# Mirvish Village Park

## What We Heard: Concept Designs

May 2021

### Concept Design

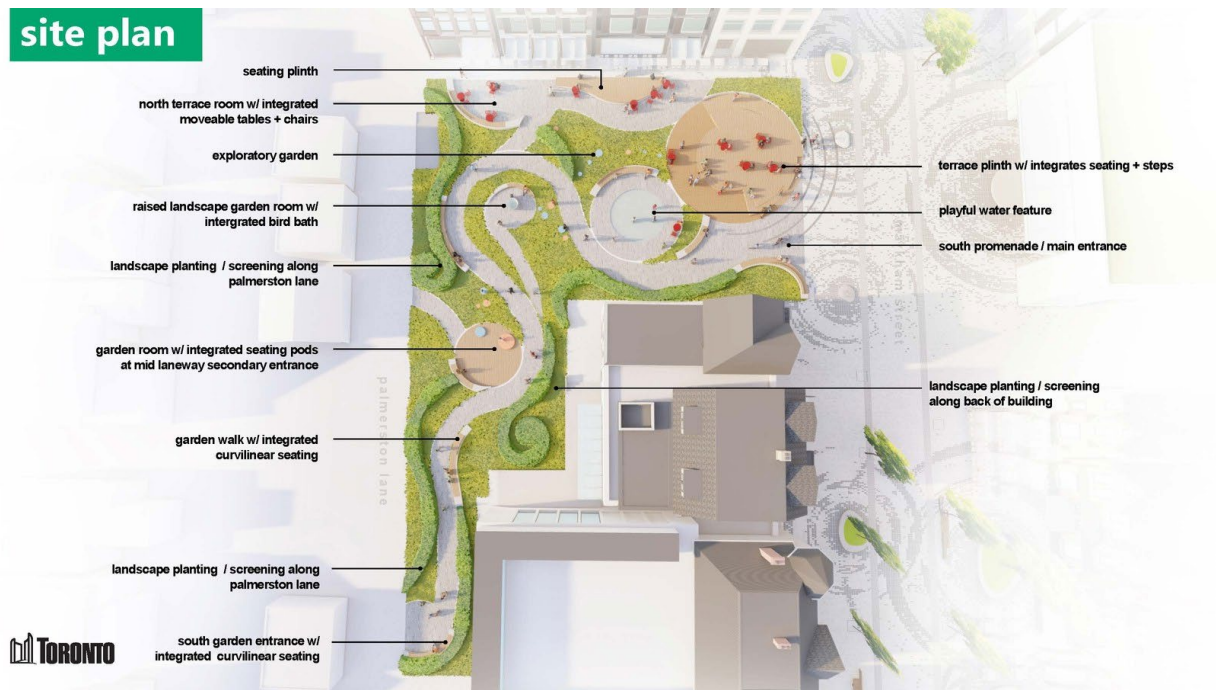
- is there a naturalized garden for attracting insects, butterflies, birds?
- bike racks
- Please add an outdoor fitness space
- Steps aren't accessible to seniors, people with disabilities, or baby carriages - gentle slopes are best.

- curvilinear walking paths look good on a bird's eye drawing but people walk in the shortest path possible
- Overall, I think it just has to be bigger, with more space. I can't imagine many people will be able to enjoy this space together.

- The sinuous path is asking people to create a direct shortcut through the planting areas.
- The bushes define but take away from free space and close it off. I'd like it more open.

- More greenery
- The winding path will make people cut across the grass from the garden room to the water feature
- The fact is the more seating and benches you add the more vagrants you attract. Minimize seating and spread it out. I live across from Allen Gardens and the amount of drug use is completely unacceptable.

- It looks like there's a lot of pavement for a park in an area that is so lacking in green. Also the paths don't cross between the two streets. I'm sure that's a design decision, but I think this park will be used as a cut-through, so we should plan for that rather than waiting for the worn path in the grass to happen (from people taking the short cut/straight line and not sticking to the planned circuitous path).

- More lawn space for sitting
- Plant native species of plants.
- Larger seating area
- There should be a bypass on the curved path, so that people don't damage greenery when cutting through the park.
